# PROFILE S.S.N<sup>o</sup> 649.

W. GRAY & CO. LIMITED  
WEST HARTLEPOOL

"Marie H. Michalinos"

Hpl. Report no. 11751

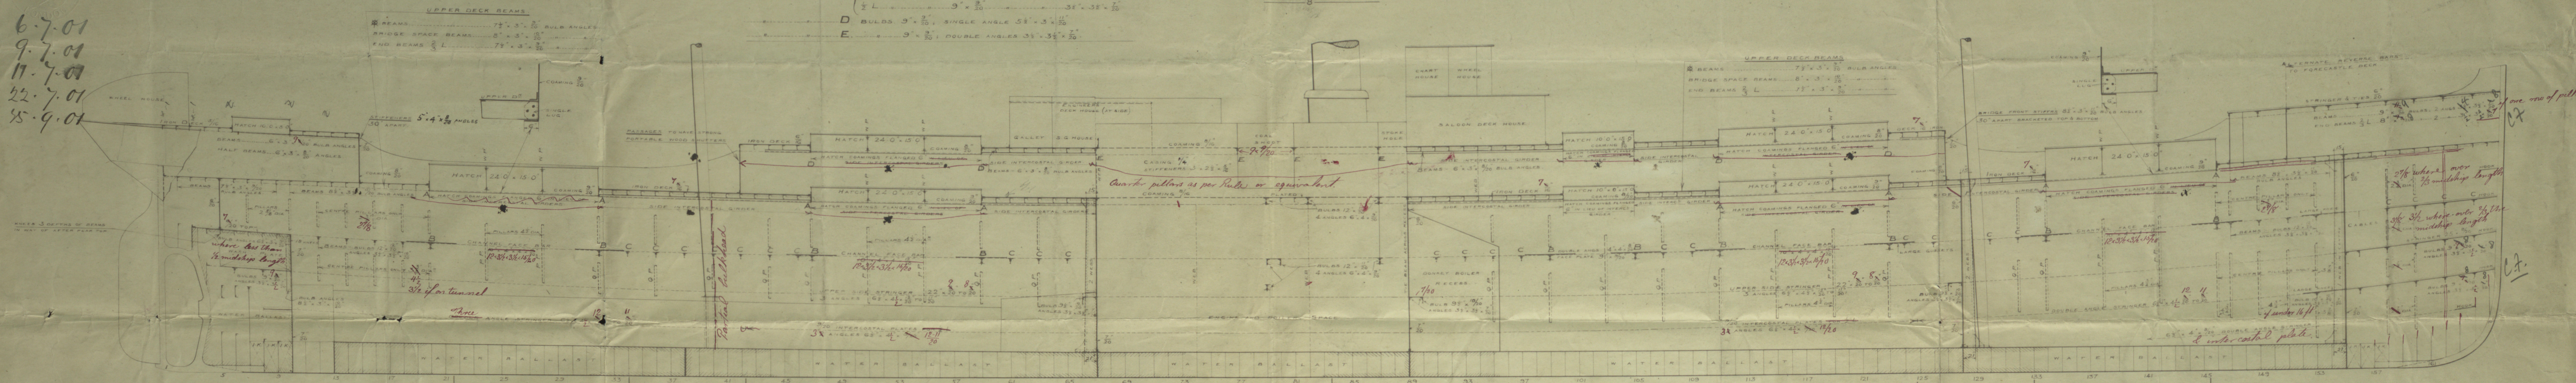
Builder proposed to flange side coamings 6" under the beams in lieu of side intercostal girders in way of hatchways approved per Sec<sup>r</sup> letter 11.25.9.01.
